PLANNING BOARD REPORT PORTLAND, MAINE

Bishop Street Apartments
72 Bishop Street
Level III Site Plan and Subdivision Review
2015-060
Avesta 72 Bishop Street, LP

Submitted to: Portland Planning Board
Date: July 10, 2015
Public Hearing Date: July 14, 2015

Figure 5: Bishop Street frontage and setback with revised landscaping

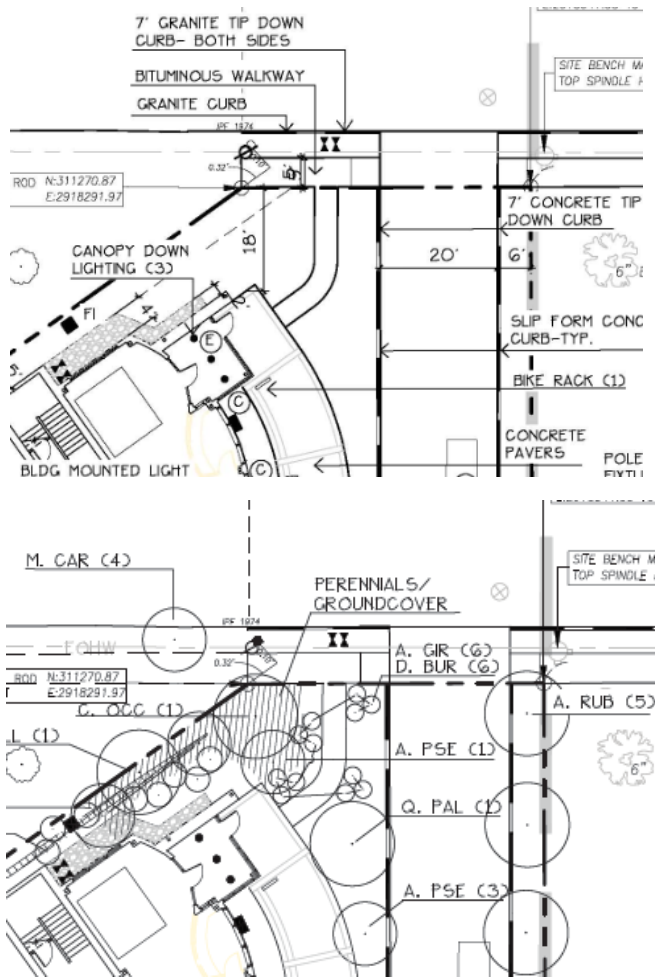
1. *Front Yard Maximum.* The B-2c zone establishes a front yard maximum of 10 feet, which the applicant continues to propose to exceed. At its closest point, the building is planned to sit 18 feet from the front property line (*Figure 5*). The ordinance does provide for an exception, stating that “the Planning Board or Planning Authority may approve a different amount for irregularly shaped lots or lots with frontage less than 40 feet provided this standard is met to the maximum extent practicable” (*Section 14-185*). The applicant has claimed in their site plan submittal that 72 Bishop is an irregularly shaped lot and that they have sited the building as close to the street as possible. The applicant writes,

The B-2 dimensional requirements also include a provision that, “[w]here setbacks exceed 10 feet, a continuous, attractive, and pedestrian-scaled edge treatment shall be constructed along the street, consisting of street trees spaced at no more than 15 feet on center, approved by city arborist, and a combination of landscaping no less than 4 feet deep, ornamental brick or stone walls or ornamental fencing” (*Section 14-185*). In the revised submittal, the applicant has added perennials/groundcover, hackberry and red maple trees, and azaleas and daphnes in the space between the building and the street line in an effort to provide sufficient edge treatment in this location (*Figure 5*). The arborist has reviewed the plans and generally found them satisfactory. The applicant is requesting that the board approve the project with the proposed deviation from the front yard maximum of the B-2c.

Figure 7: Existing transit service, Morrill’s Corner

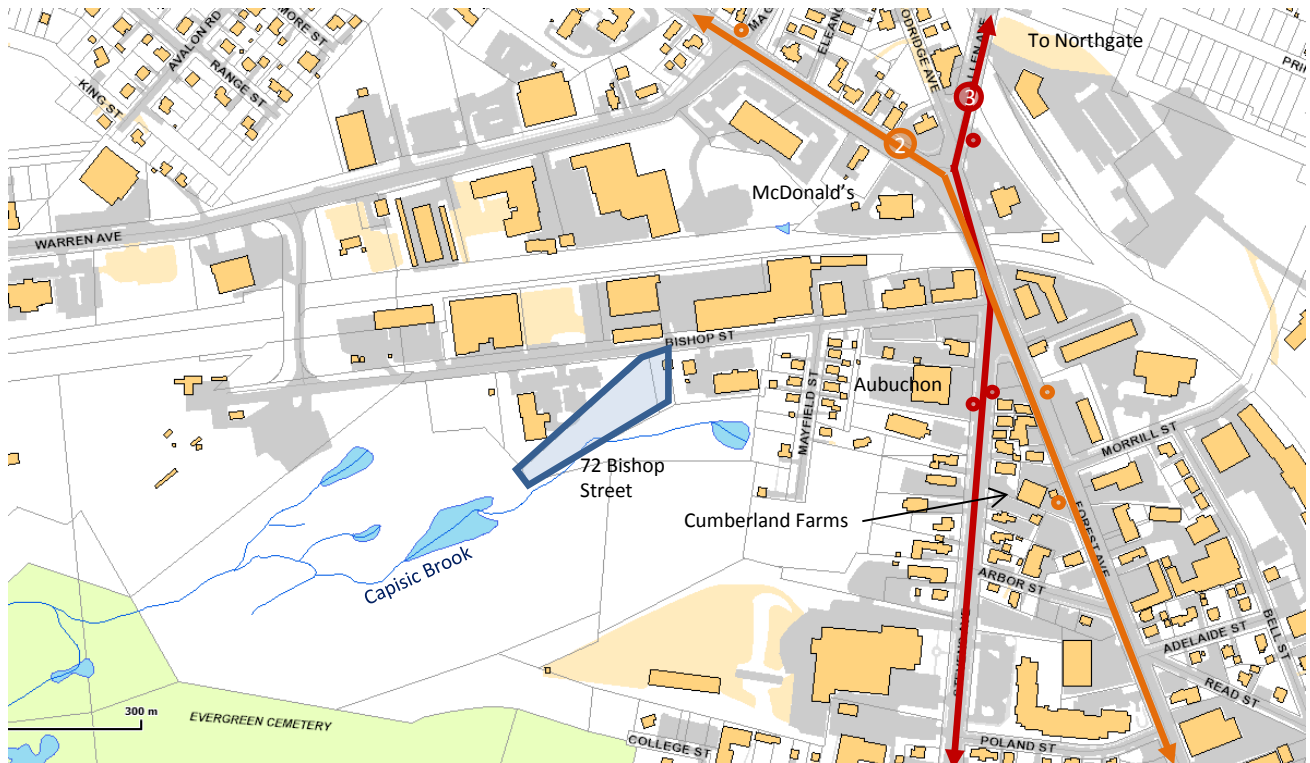
The proposed development is not located along a public transit route (*Figure 7*). As such, no provisions for transit access are required on the site. The proposed sidewalk to Morrill’s Corner, assuming it extends to Stevens Avenue, will serve as a pedestrian connection to existing transit service. At the board’s request, staff has approached Metro regarding current plans to rearrange existing bus stops at Morrill’s Corner. No response was received from Metro prior to the publication of this report. Bruce Hyman, the city’s Transportation Program Manager, is pursuing the potential for relocating bus stops with Metro.
